# Project T10/1826-D

Revision 05   
 22 June 2008

## Information technology - SCSI / ATA Translation - 2 (SAT-2)

# Summary of Comments on SCSI / ATA Translation Standard

Figure 2 — ATA document structure

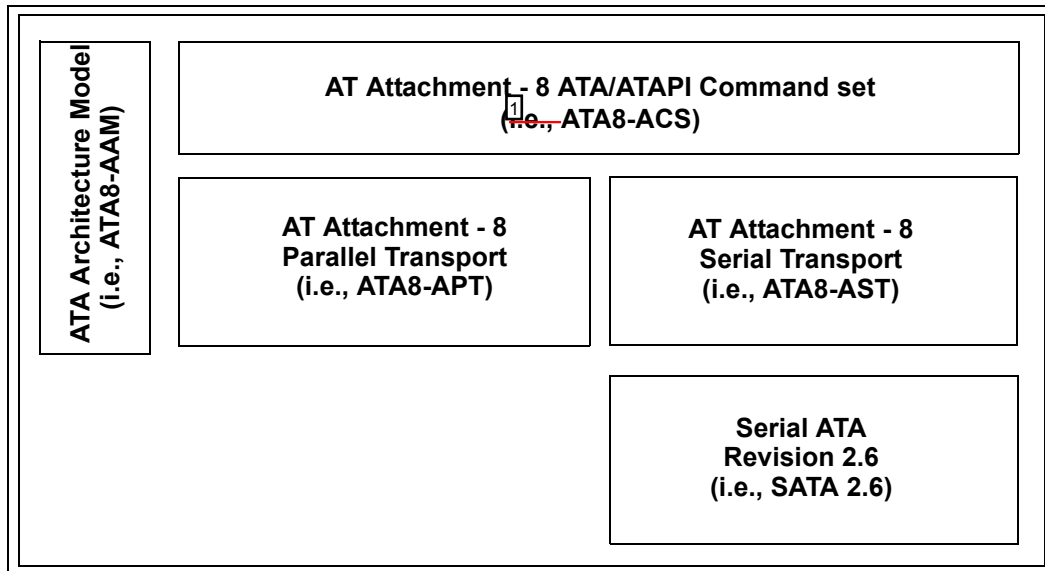
Delete all the "i.e."s from figure 2. That is not used for acronyms in parenthesis - just the acronym is fine, like "(ATA8-ACS)"

moverby Accepted 9/11/2008 11:33:18 AM -07'00'

Figure 3 — SCSI / ATA Translation document role

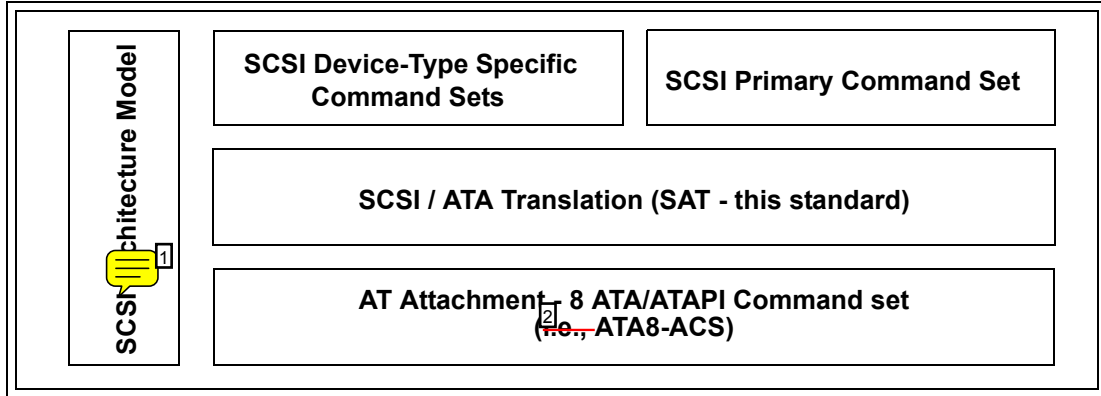
Number: 2 Author: HPQ-RElliott Subject: Cross-Out Date: 9/3/2008 9:42:24 AM -07'00'  
Delete i.e., in figure 3 (see reasoning in comment on figure 2)

**Figure 10 — Translation of Logical Sector Alignment (part 3)**

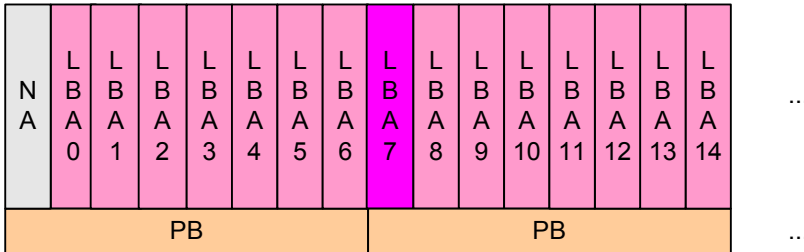
the READ CAPACITY (16) data.  
s/b  
the READ CAPACITY (16) command data.

Number: 1 Author: Kevin\_Marks Subject: Highlight Date: 8/11/2008 12:51:30 PM -07'00'  
Figure 10 missing reference in text

moverby Accepted 10/20/2008 1:39:25 PM -07'00'  
Author: moverby Subject: Sticky Note Date: 10/20/2008 1:39:22 PM -07'00'  
READ CAPACITY (16) parameter data.
